CITY OF ALBUQUERQUE

Sites: Preserve at Woodmont - C09E015

Re: Drainage Ordinance (14-5-2-11) Violations for Erosion and Sediment Control

Jun 2, 2022 at 10:47:14 AM
Woodmont Ave NW
Albuquerque NM 87114
United States

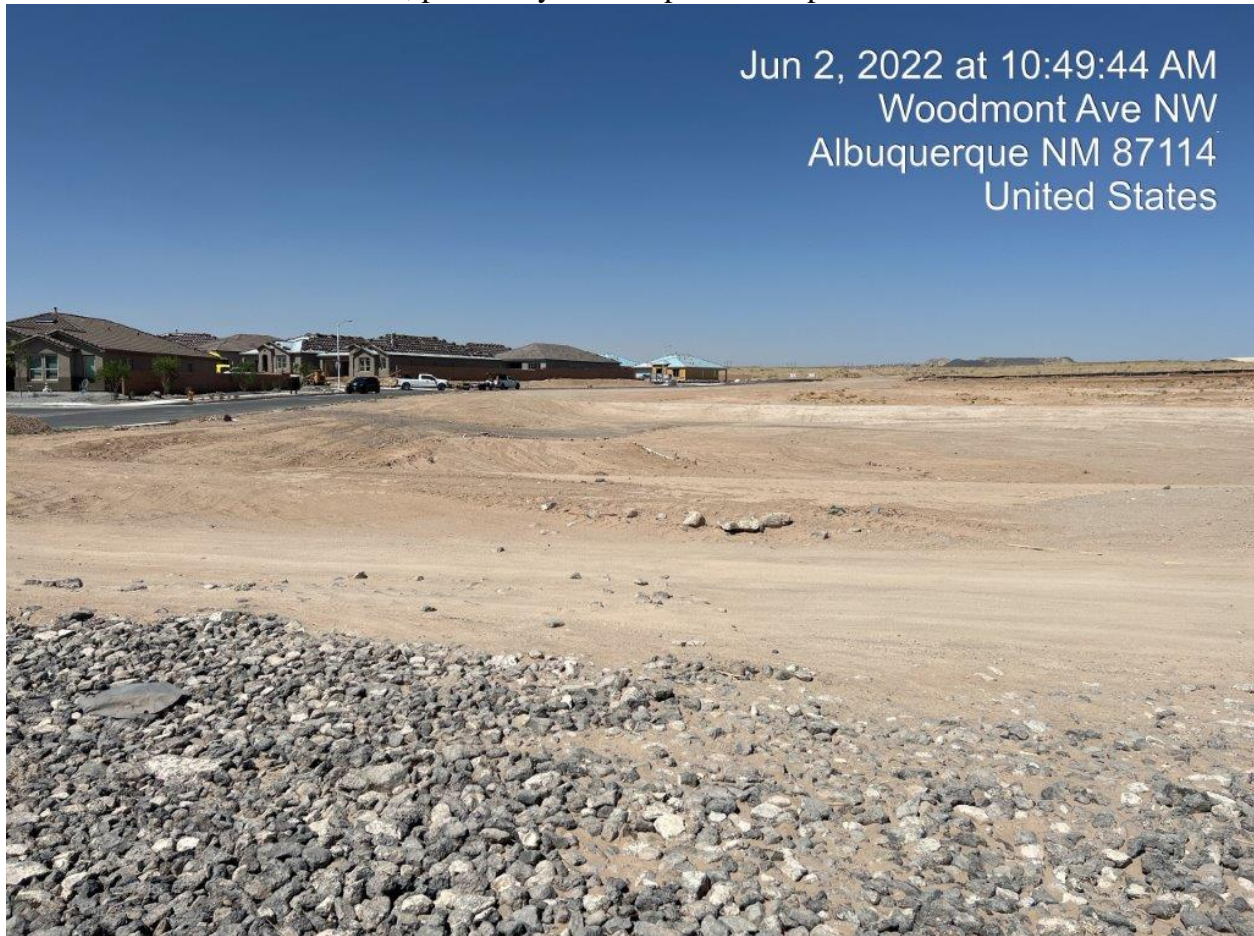
1. The up-to-date SWPPP was not available onsite. (2nd Violation Notice.)
2. Silt Fence (SF) was missing across the south property line, and on both sides of the disturbed area in Woodmont. (2nd Violation Notice.) Some dilapidated SF is located at the toe of the slope east of Woodmont that should be reset, preferably at the top of the slope.

1. The SWPPP must be kept up-to-date and available onsite per CGP Part 7.1. If an on-site location is unavailable to keep the SWPPP when no personnel are present, notice of the plan's location must be posted near the main entrance of your construction site CGP Part 7.3.
2. Install and repair all BMPs. Ensure that all stormwater controls (BMPs) are maintained and remain in effective operating condition during permit coverage per CGP Part 2.1.4. If at any time you find that a stormwater control needs routine maintenance, you must immediately initiate the needed maintenance work, and complete such work by the close of the next business day. When the problem requires a new or replacement control or significant repair, install the new or modified control and make it operational, or complete the repair, by no later than seven (7) calendar days from the time of discovery per CGP Part 5.
